NEW BRITAIN - HARTFORD BUSWAY

PERMITTING SUBMISSION

EAST MAIN STREET STATION

**8. Appendix E: CTDOT Preliminary Design
Comment Responses**

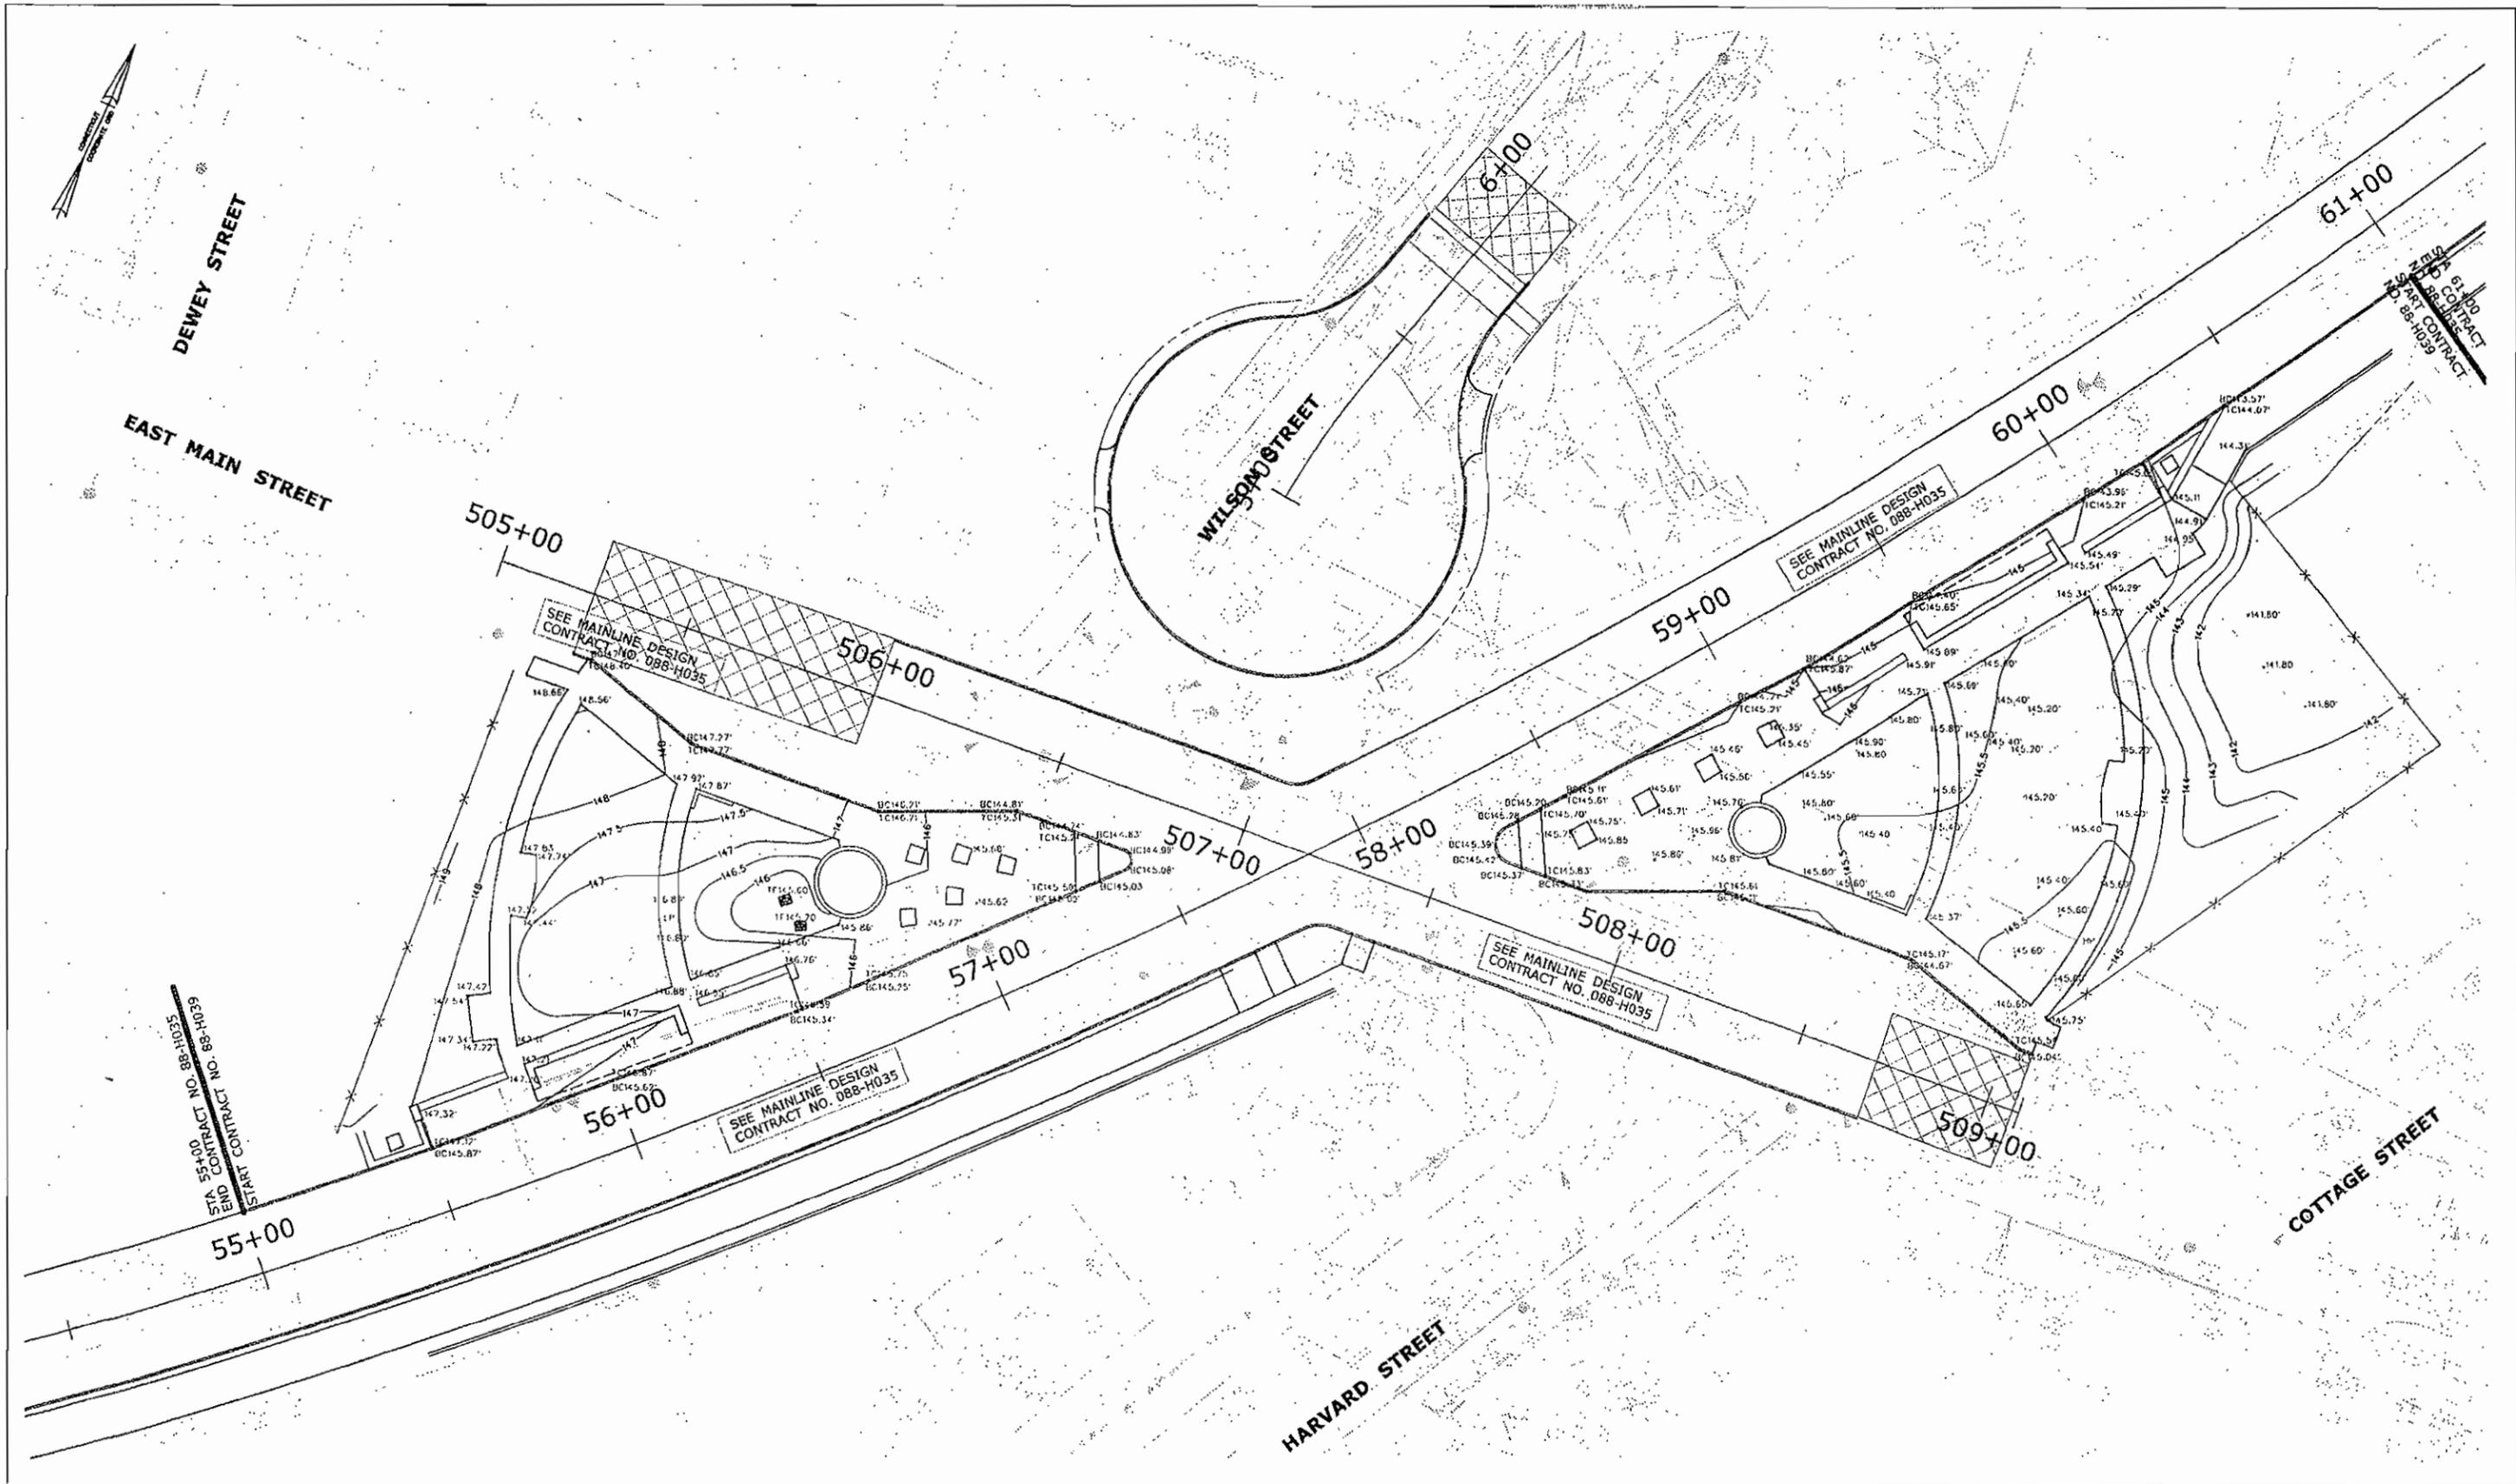
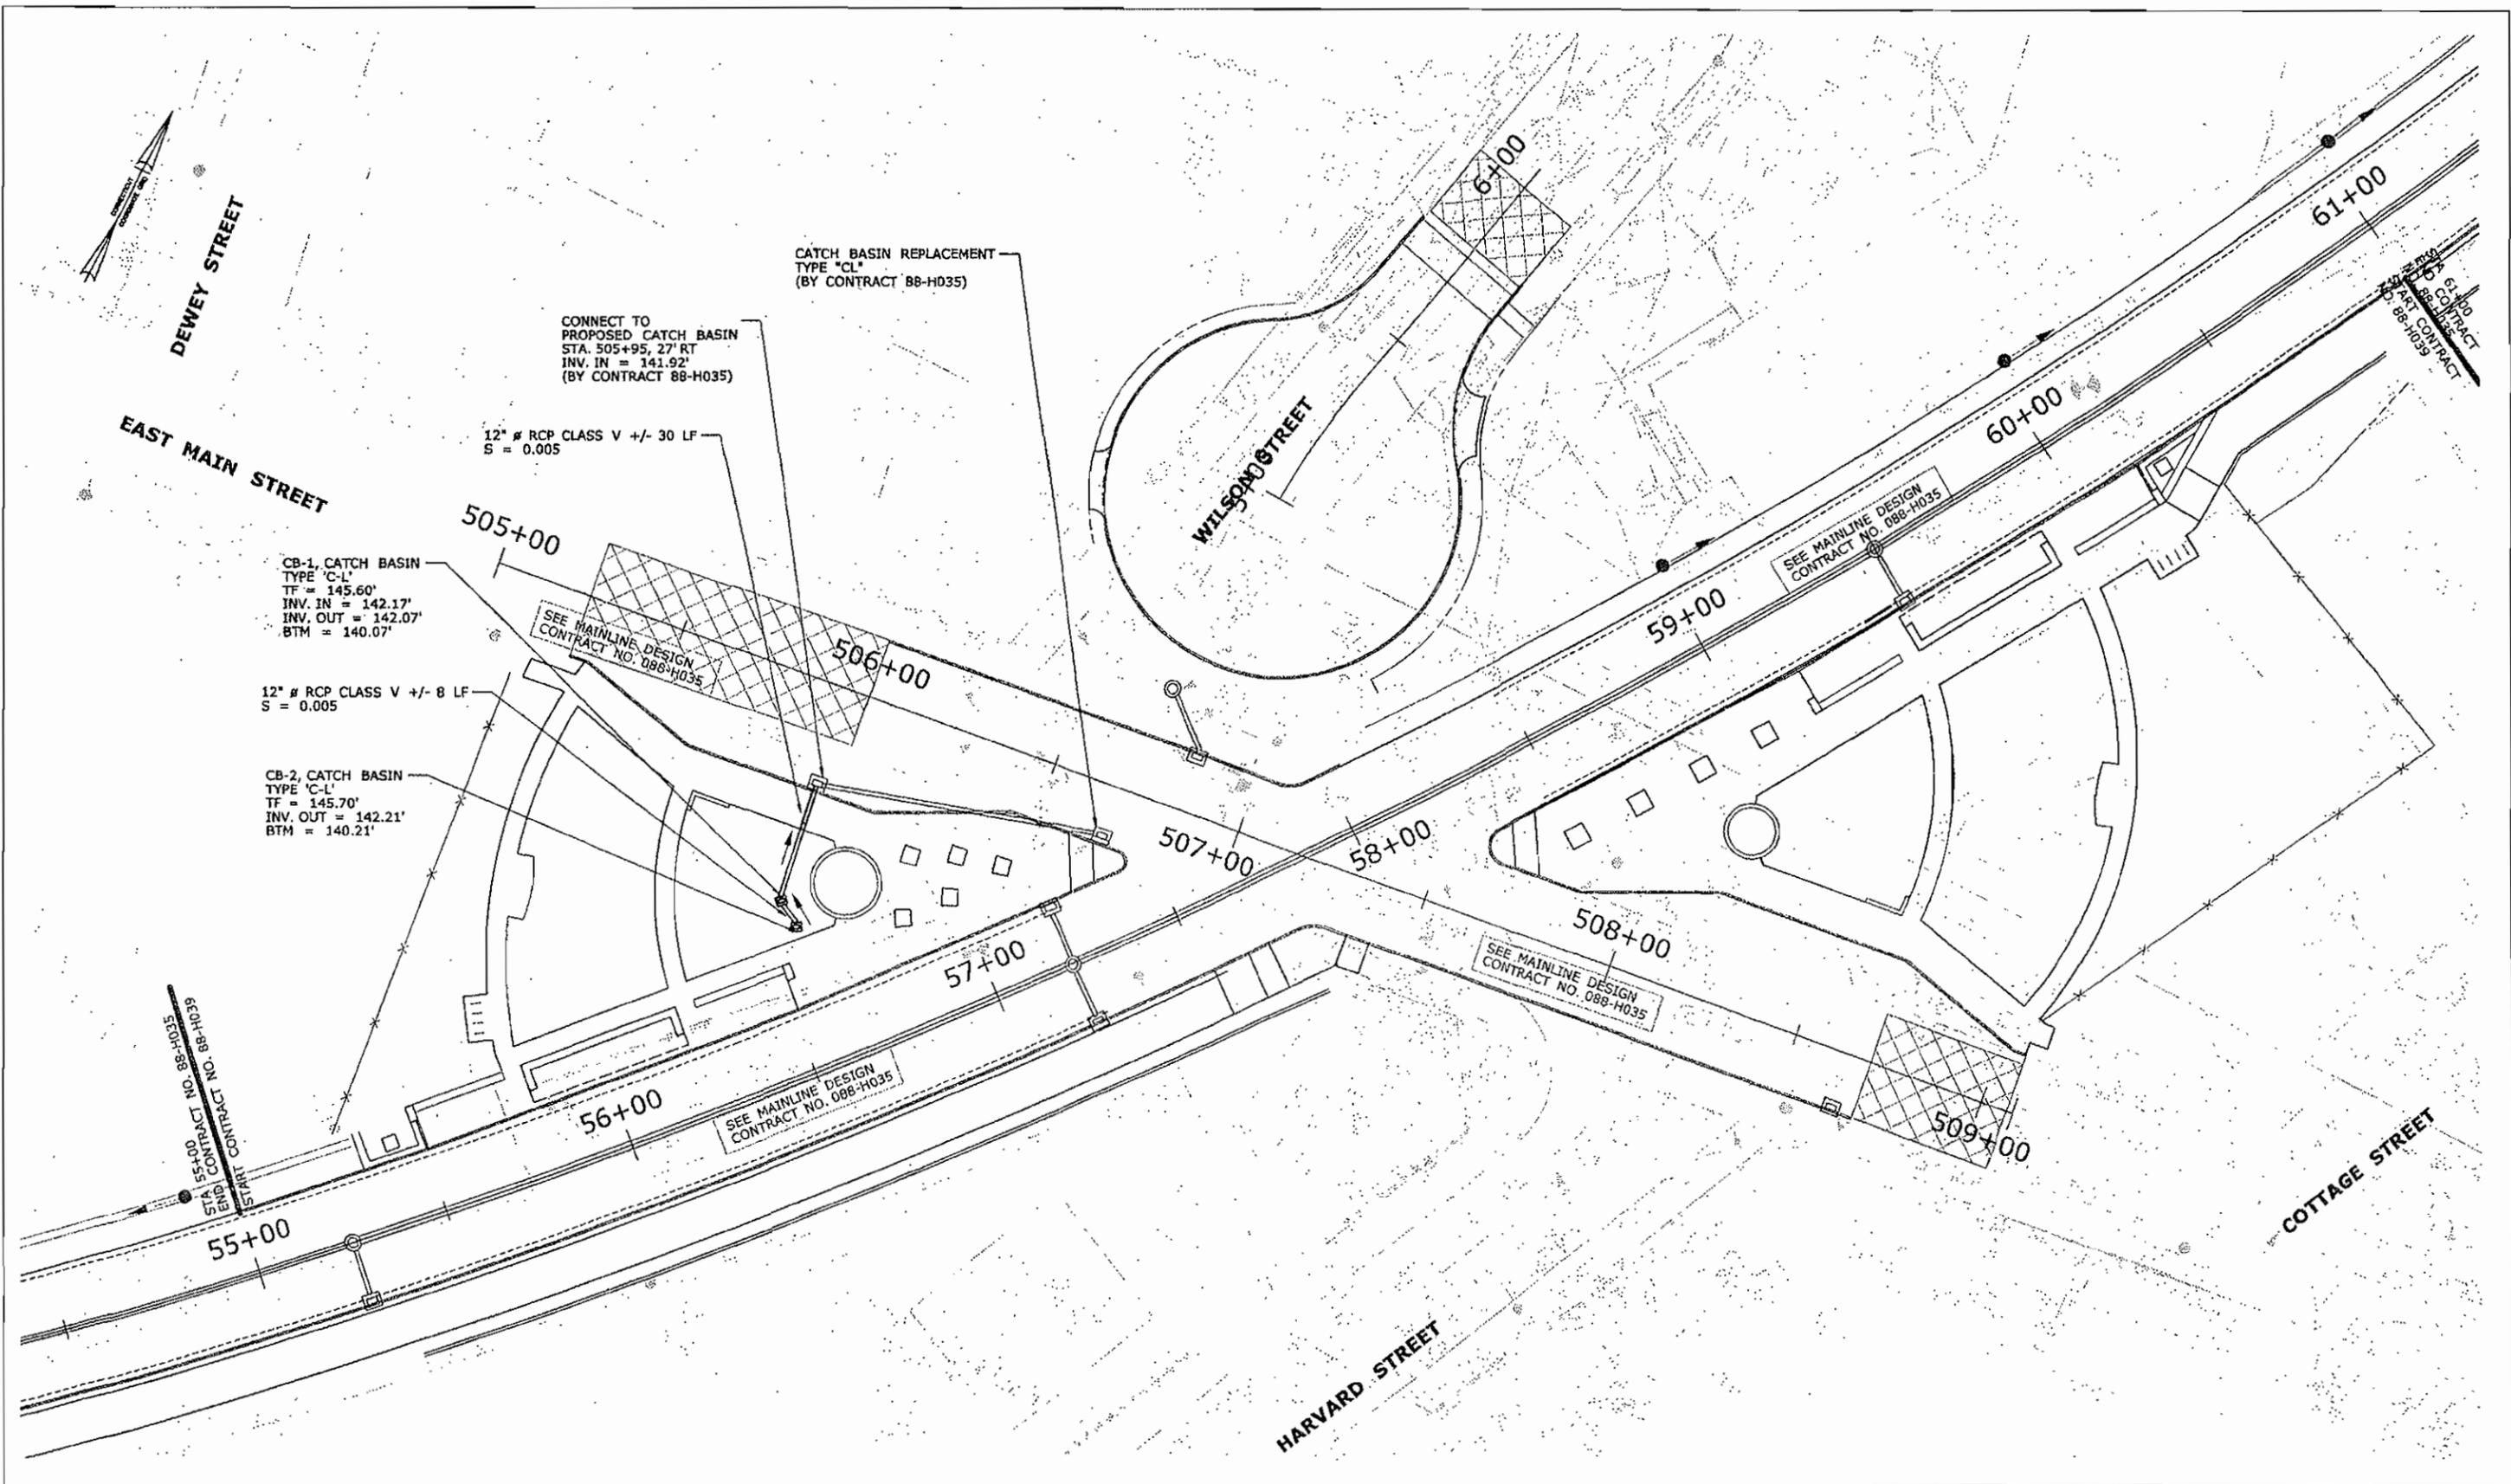
Comment #	Loc. or Shoot #	Comment	Inc.	Not Inc. (If not, WHY)
5	CIV-XX	<ul style="list-style-type: none">The CIV plan sheets shall include the Station markings, toe of slope, drainage, cut and fills, and E&S controls, etc...Please coordinate with the project designers of Project 88-H035 regarding the transition points connecting concrete curbing, RW, drainage, etc...between the busway and platform stations.		
7	DRG	<ul style="list-style-type: none">Since the station will have limited access, the drainage design should consider alternative pipes. Determination should be based on overall cost savings.Why is the design proposing Class V pipe within the Station footprint where there is pedestrian traffic only?		
8	LDS	<ul style="list-style-type: none">Remove Meadow Mix from the project.Be sure to use turf establishment as the proper term in lieu of the term Lawn.

Reviewer Comment 5a)

- The CIV plan sheets shall include the Station markings, toe of slope, drainage, cut and fills, and E&S controls, etc...

SEA Response: *Sheets have been updated, as appropriate.*
